From: kimberly@lundbergtaylor.com
Sent: Tuesday, March 1, 2022 8:26 AM
To: mvanderhurst@visitmammoth.com; jenb2374@gmail.com; Paul Chang; jessicarskennedy@gmail.com; eckertimmth@verizon.net; Lynda Salcido; Sarah Rea; Jamie Gray; Sandra Moberly; John Wentworth; Bill Sauser; Kirk Stapp
Subject: Comment re Villas III PEDC hearing March 2, 2022
Attachments: Villas-III Opposition PEDC 2022-03 public hearing 20220301_KTaylor.pdf

To: Town of Mammoth Lakes Planning and Economic Development Commission,
Commissioners Vanderhurst, Burrows, Chang and Kennedy

Subject: Opposition to proposed Villas-III development plans at 100 Callahan Way

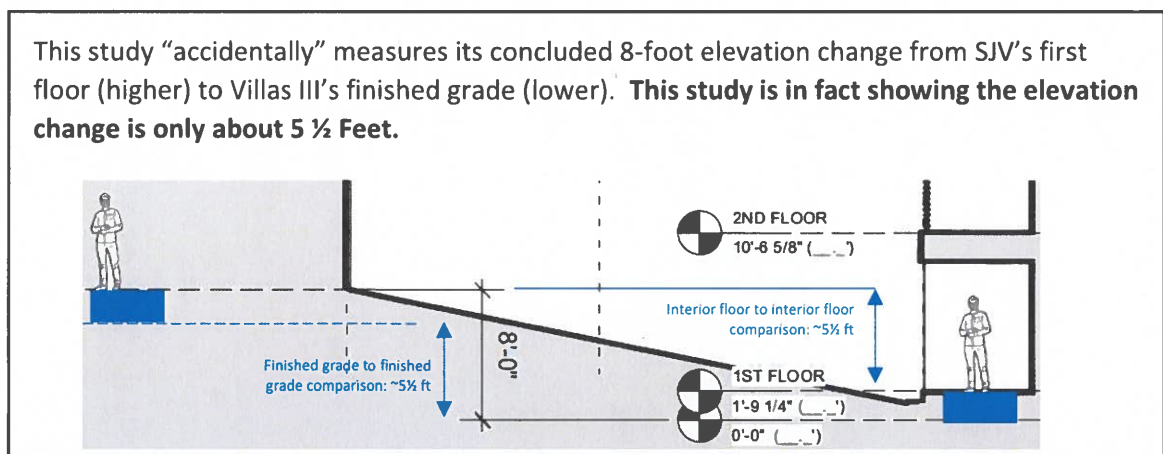
This so-called “study” does not use actual building dimensions and is a deceitful attempt to deliberately misconstrue the negative effect that the Villas III duplex units 22-25 will have on San Joaquin Villas (SJV) E-building. To start, their “study” misrepresents size of the buildings to downplay the difference of the structure size.

Additionally, this study **misrepresents the relative height** between the SJV E-building and Villas III duplexes by using inconsistent reference points between the two structures. Maximum building height is measured from the finished graded adjacent to the building exterior to the highest roof peak. This “study” does not use “apples-to-apples” references. Both structure heights should be measured from finished grade (indicated by horizontal blue dashed line on SJV image, and the zero-reference on the Villas III image).

By misrepresenting both the SJV image proportion and the incorrect height reference point, this “study” attempted diminish the actual impact of the Villas III duplex 35-foot height.

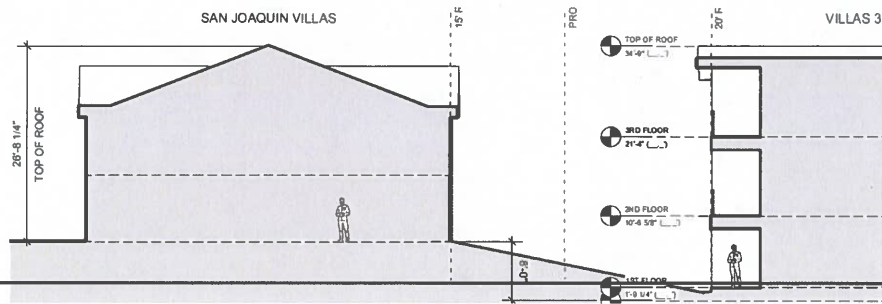
This “study” also misrepresents the relative **Heights** of the SJV E Building and the Villas III duplexes (p. 69/74). It shows the tops of the 2 buildings to be the same height. It claims SJV is 26’ - 8 1/4” and Villas III is 34’ - 9” tall. The actual difference in height would be 8’-3 3/4”. However, the previous paragraph proves that the Elevation Change is actually about 5.5’. Their error is almost 3’ in height, which is an **error of more than 10% relative to SJV’s height**.

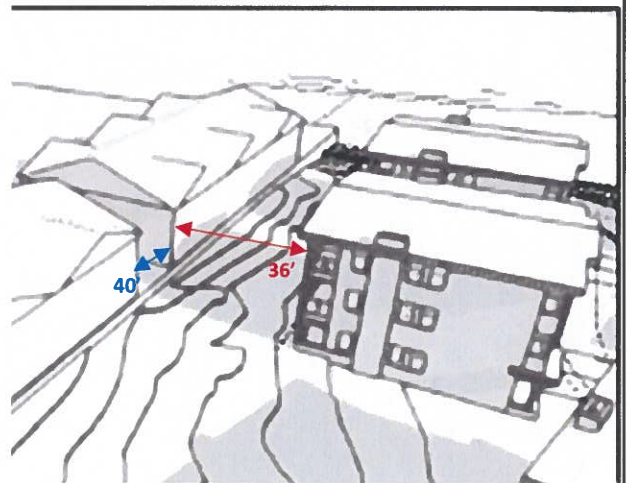
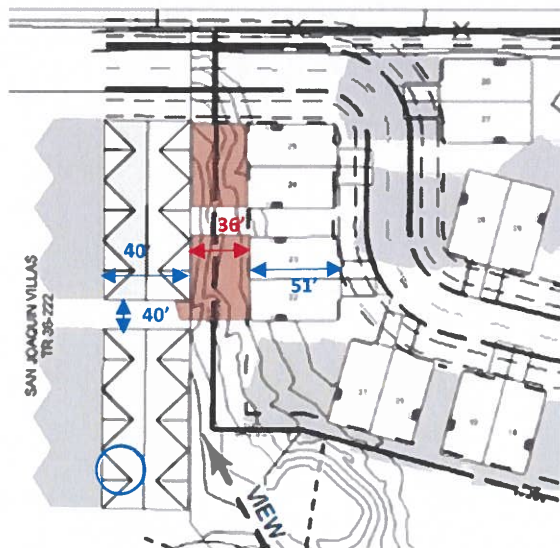
The **distances between buildings** are also misrepresented, as can be seen by the images below with the actual dimensions applied.

The distance between Villas III and SJV E-building (36’) is shown inaccurately as significantly larger than the distance between SJV’s E- and D-buildings (40’).

9AM

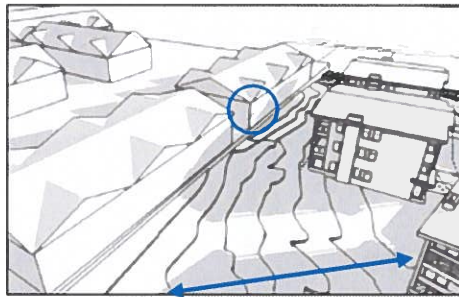
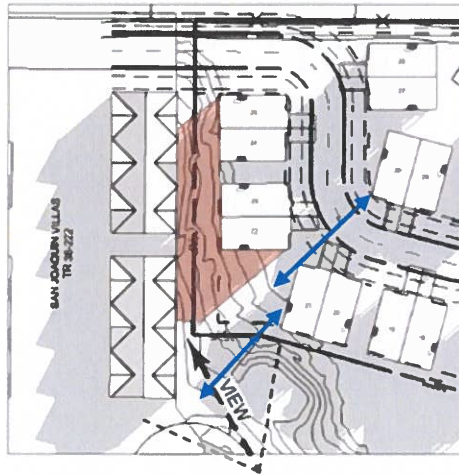
The Solar Study (Project Plans p.72/74) shows these Winter Solstice 9AM long shadows cast by Units 28 and 18-21 (blue arrows) are approximately 120 feet long. The (orange) indicates shadows cast by units 22-25 onto E-building.

These Winter 9am shadows cast by units 22-25 (orange) will impact and overshadow SJV E-building and half of SJV D-building by a significant amount.

Yet this simulated study inconsistently indicates my home will get sunshine during this long shadow period when units 22-23 are just 36' away ?? – inaccurate.

12PM

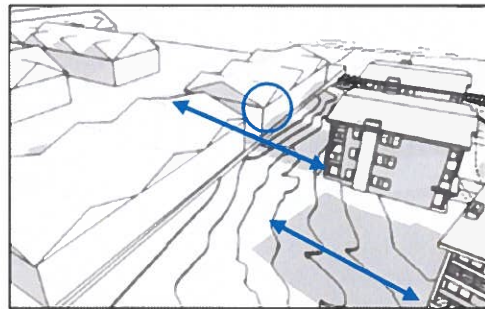
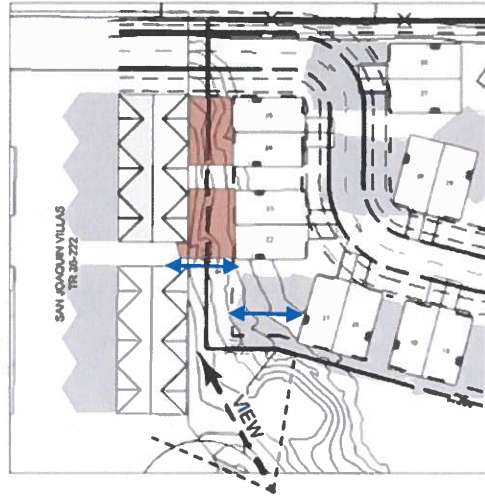
These Winter Solstice 12PM shadows cast by units 21 (shadow length indicated by blue arrow; note both shadow length and width) compared to units 22-25, which are the same size and would cast the same size shadow.

The second blue arrow shows the length expected from units 22-25, however the lower image unexpectedly shows sun on the E-building when the unit 21 shadow length clearly indicates there would not be sun in this location.
